Sunnyside Cogeneration Associates

RE: Sunnyside Refuse and Slurry C/007/0035
Permit Amendment – Road S Post Construction Update

Title: UPDATE POST CONSTRUCTION - ROAD S, DRAINAGE AND CULVERTS NEAR PASTURE POND

PASTURE SEDIMENT POND - Hydrologic Calculations

SHEET **7-1**

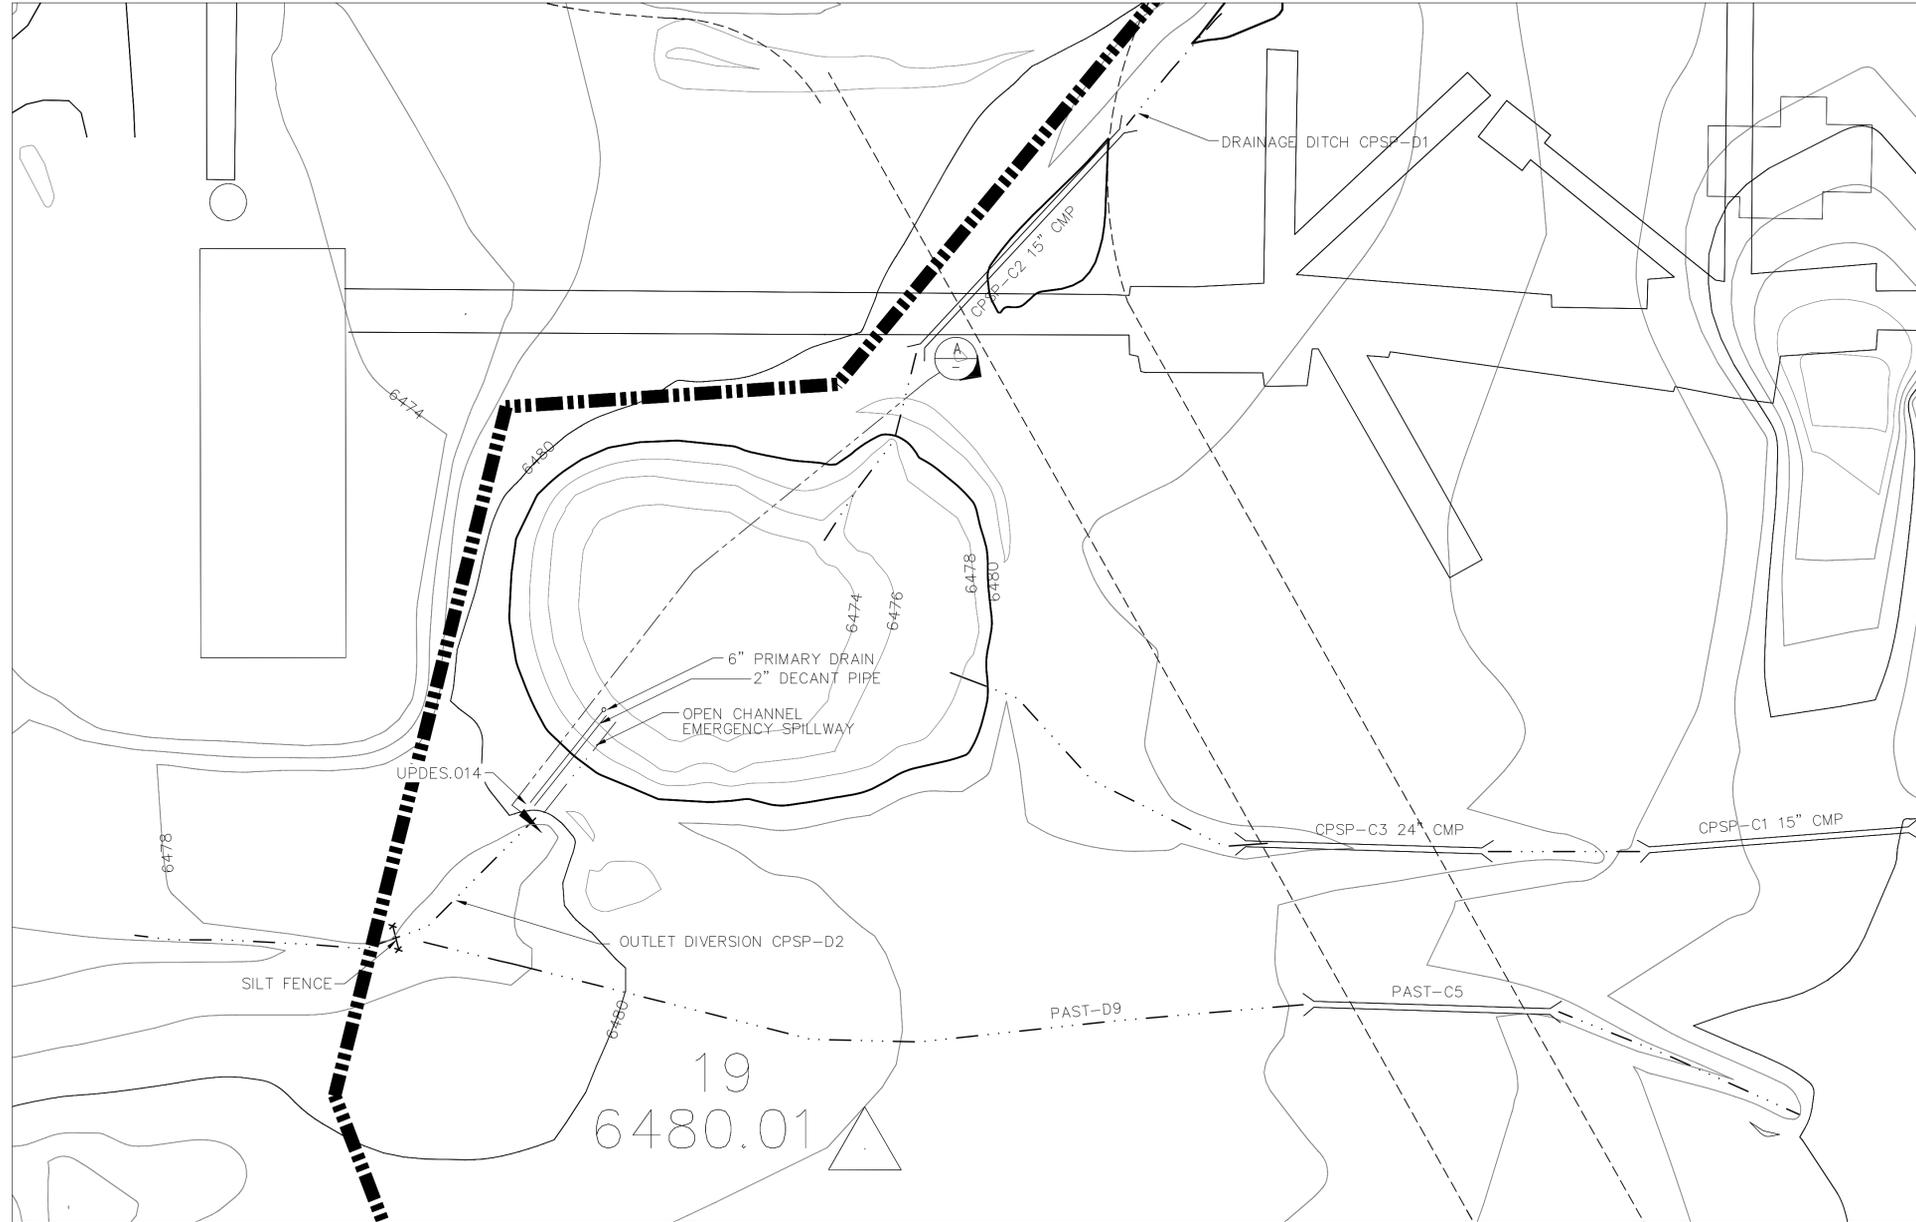
SCA is submitting the enclosed permit amendment to more closely reflect the post-construction conditions following completion of the Road S construction near the pasture pond.

This amendment updates ditches and culverts crossing this new road.

Construction of Road S is completed, updated to more closely reflect conditions as constructed

REV	DATE	DESCRIPTION
1	10/16	POST CONSTRUCTION UPDATE FOR ROAD S
2	1/16	EXCESS SOIL DISPOSAL AREA RECLAMATION UPDATE
3	7/15	REMOVE CULVERTS IN PASTURE POND DRAINAGE AREA
4		ADD DITCHES AND CULVERTS IN RAIL CUT DRAINAGE
5	11/10	BOUNDARY UPDATE
6	8/10	UPDATE SITE AND TOPO
7	5/08	MOVE PASTURE POND CULVERT-C1
8	5/07	UPDATE PASTURE POND

Sunnyside Cogeneration Associates
COAL PILE/SEDIMENT POND
AND CROSS-SECTION

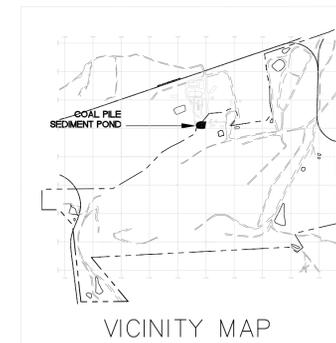
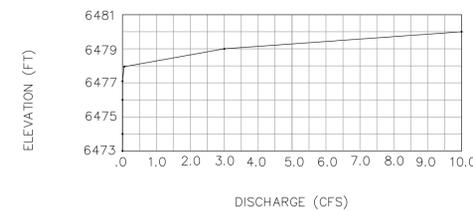
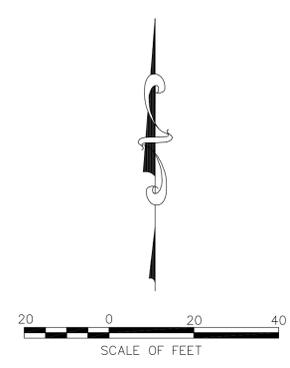
The pond can discharge through an 18 inch culvert when the water level reaches the stage elevation of 6490.6 (6.1 feet deep). The 18 inch pipe spillway is capable of passing the 25 year, 6 hour peak flow. The pond treats the 10 year, 24 hour storm such that effluent is well within the UPDES limits. ~~In 2015, the ditch leaving the discharge point from the Pasture Pond was re-routed to flow into the Coal Pile Sediment Pond (014). This provides a backup treatment option in the event of any discharge from the Pasture Pond.~~

The 18" CMP Emergency Spillway is required to be designed to safely pass the 25 year 6 hour storm. It is also required that the discharge be controlled in a manner to reduce erosion and to minimize disturbance to the hydrologic balance. Hydrologic modeling projects that the 25 yr 6 hr storm would not have a discharge from the pond. The 100 year 6 hour storm is projected to have a 3.98 cfs discharge (See tables above for Past D9 / outlet). The spillway and outlet ditch D9 were designed to pass the 100 year storm with velocities less than 5 ft/sec to reduce erosion and minimize disturbance to the hydrologic balance. The outlet ditch flows to ~~the Coal Pile Sediment Pond (014)~~ an existing surface drainage swale.

REV	DATE	DESCRIPTION	BY	APP'D
△	10/15	REDIRECTED WATER FROM PASTURE POND	AH	
△	9/02	2002 PERMIT RENEWAL		
△	8/95	ADDED 6' SILT FENCE		
△	1/95	ADDED 2" DECANT PIPE		
△	6/93	ADDED SLOPE TO CMP
